Objection to Planning Permit Application

Name:	
Postal address:	
Telephone number:	
Email address:	
What is the permit application number?	116/2021/P
What is proposed?	14 Dwelling Apartment Building with Basement Parking
Application address?	48 Railway Parade, Seaford
Who applied for the permit?	Fletcher Development Consultants Pty Ltd

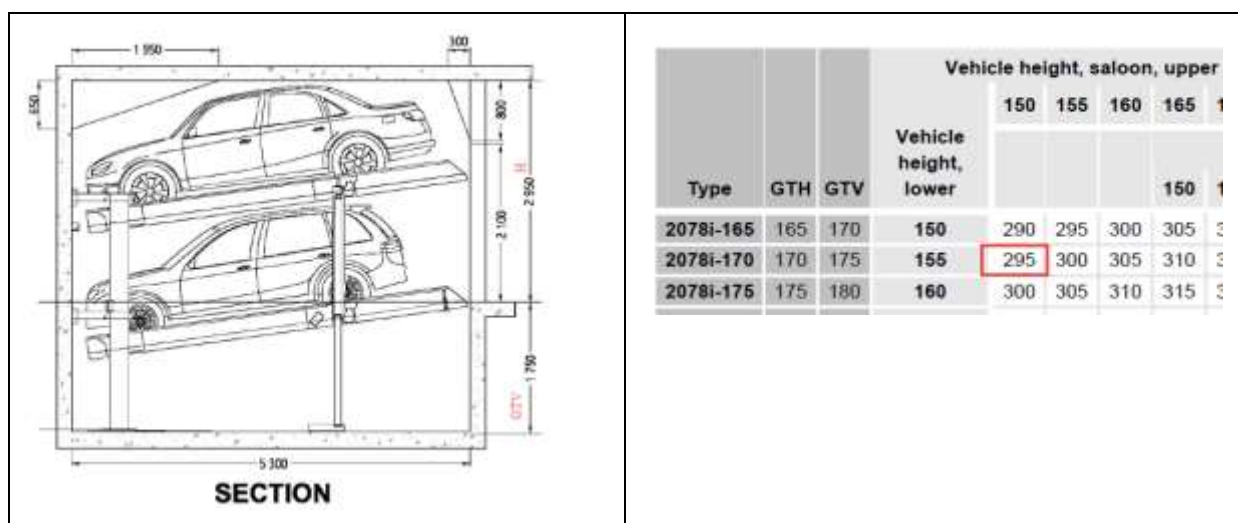
All measurements are extremely tight for opening doors to exit the vehicle and no consideration appears to have been given to **disabled parking** (AS2890.6-2009).

Some of the vehicles are simply too high to fit.

55.03-10 indicates all vehicles will be able to turn smoothly and leave the carpark in a forward motion but the guidelines from Klaus and 52.06-9 give the impression the access lane is not wide enough to do this by at least 1 metre.
